RE: Initial Submission Review

Aspen South Lateral - Site Plan Amendment #15
Location: QS:97AA – 56th Ave and Monaghan Rd
Case Number(s): 2023-6048-10

ASPEN SOUTH LATERAL - SITE PLAN AMENDMENT #15

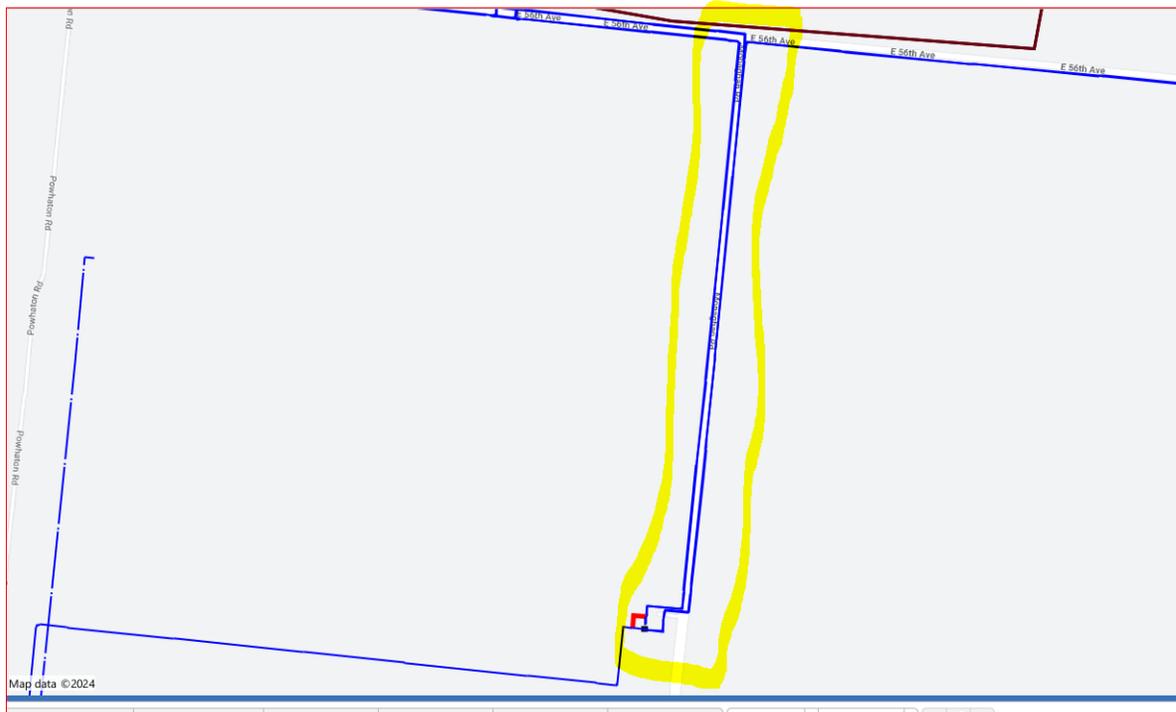
Public Service Company of Colorado's (PSCo) Right of Way & Permits Referral Desk has determined there is a potential conflict with the above captioned project. Public Service Company has existing electric transmission lines and associated land rights crossing the project at the East 48th Avenue alignment. Any activity including grading, proposed landscaping, erosion control or similar activities involving our existing right-of-way will require Public Service Company approval.

Encroachments across Public Service Company's easements must be reviewed for safety standards, operational and maintenance clearances, liability issues, and acknowledged with a Public Service Company License Agreement to be executed with the property owner. PSCo is requesting that, prior to any final approval of the site plan, it is the responsibility of the property owner/ developer/ contractor to have this project assigned to a Land Rights Agent for development plan review and execution of a License Agreement (via either website www.xcelenergy.com/rightofway or email coloradorightofway@xcelenergy.com).

PSCo also owns and operates existing both overhead and underground electric distribution facilities along Monaghan Road. Bear in mind that per OSHA standards, a minimum 10-foot radial clearance must be maintained at all times from all overhead electric facilities including, but not limited to, construction activities and permanent structures.

Note that proper clearances must be maintained including ground cover over buried facilities that should not be modified from original depths. In other words, if the original cover is changed (by less or more), PSCo facilities must be raised or lowered to accommodate that change. Contact Colorado 811 for locates before excavating. Use caution and hand dig when excavating within 18-inches of each side of the marked facilities. Please be aware that all risk and responsibility for this request are unilaterally that of the Applicant/Requestor.
